Leanos Estates Plat 1 – Major Preliminary Plat

- Applicant:** Eric Leanos (Property Owner / Developer) represented by Vic Piagentini with Associated Engineering Company of Iowa, Inc.
- Request:** Preliminary Plat Approval of a Major Subdivision Plat

STAFF REVIEW:

Leanos Estates Plat 1
 Major Preliminary Plat

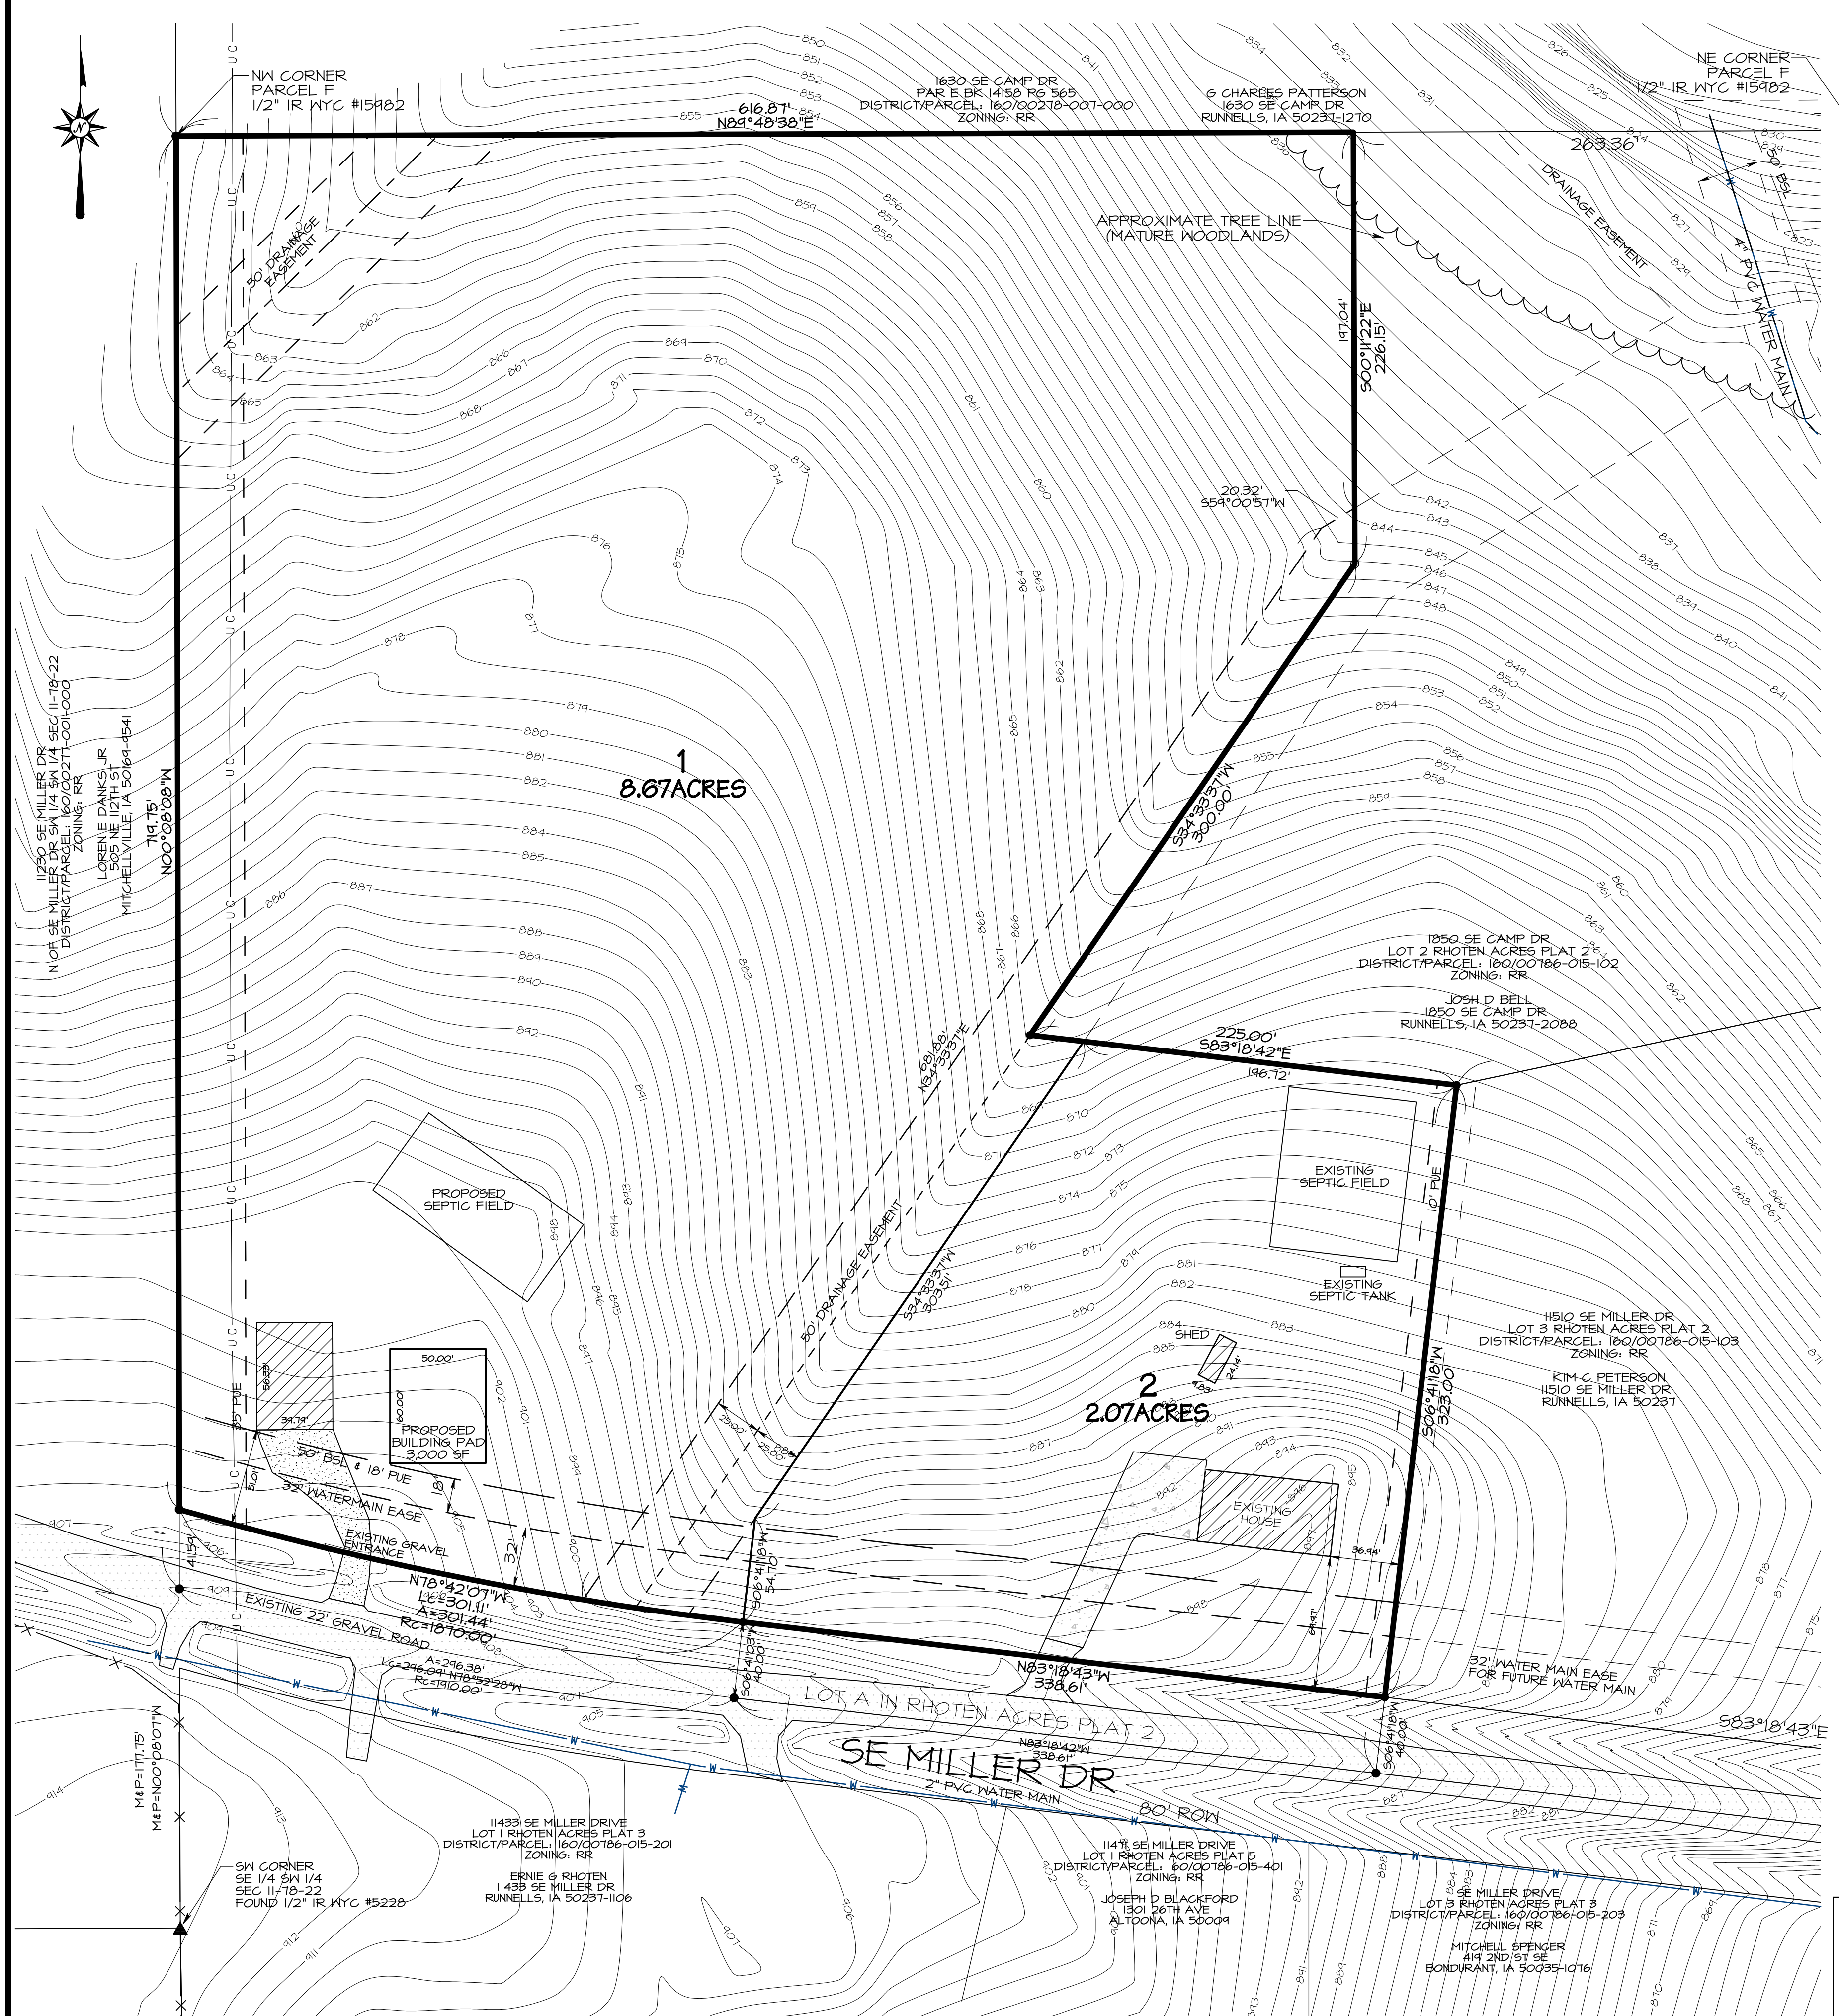
Staff review took into consideration the future growth of this area in accordance with the Comprehensive Plan and the intent for orderly and beneficial development as outlined by requirements within the Subdivision Ordinance. The frontage of the subject property is along the gravel roadway of SE Miller Drive. The current standards require hard surface improvements for more than one (1) lot proposing to utilize the gravel roadway. Text Amendments to the Polk County Subdivision Ordinance were approved in January of 2017 and included the current standard referenced above. The intent of this standard is to prevent continual divisions within rural parts of the County, where new lots access gravel roadways. The standard allows for a one-time plat of survey within a tract of record, or 40-acre aliquot part, to create a single buildable parcel fronting an existing gravel road. Subsequent divisions within the same aliquot part trigger the requirement for hard surfacing improvements across the frontage of the development, including connection to the nearest paved roadway.

This area has previously been platted several times with repeated division occurring within the same tract of record along SE Miller Drive. This type of development pattern reinforced the necessity for the requirement that hard surface improvements be made for development proposing more than one (1) lot with frontage along a gravel roadway. This information was specifically shared with the owner/developer of this proposal prior to the commencement of the Leanos Estates Plat 1 Preliminary Plat. Rhoten Acres Plat 5 was referenced within the waiver request, however, that plat created a new lot with frontage and access along SE Camp Drive, and therefore did not create an additional access point onto SE Miller Drive.

The Polk County Engineering Division has provided an estimate of \$85,000 for 1,200-feet of roadway to be hard surfaced as part of the County's annual overlay work. The hard surface improvements would start at the intersection of SE Camp Drive and SE Miller Drive and would extend to the western property line of the subject property.

Staff recommends denial of the Preliminary Plat of Leanos Estates Plat 1, as well as the requested waiver to the hard surface roadway improvements. Staff would support the proposed Preliminary Plat of Leanos Estates Plat 1 with the condition that the required hard surface improvements from the intersection of SE Camp Drive and SE Miller Drive extending west across the entire frontage of the subject property be completed or bonded for prior to final plat approval.
